928 Texas Ave.

# **Staff Report**

## Infill Housing Design Review

File Number: 5-F-25-IH

FOUNDATION PLAN FLOOR PLAN

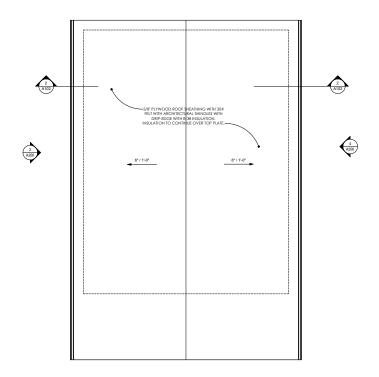
- 3. Infill Housing design guidelines recommend that parking be accessed from the alley, if there is one. Parking is a concrete pad located in the front yard and accessed from Texas Avenue. Parking should be revised to avoid the front yard and be accessed from the rear alley, and the final site plan should meet City Engineering standards.

- 8. The asphalt shingles and vinyl lap siding meet the design guidelines. The block foundation should be clad in stucco or parge-coated to meet design guidelines. The final siding material should feature an overlap, as opposed to Dutch lap or flush panel siding.

Staff recommends approval of Certificate 5-F-25-IH, subject to the following conditions: 1) the final site plan to meet City Engineering standards; 2) the final site plan to include a walkway from the front porch to the street; 3) parking to be revised to meet design guidelines; and 4) the foundation to be parge-coated or clad in stucco.
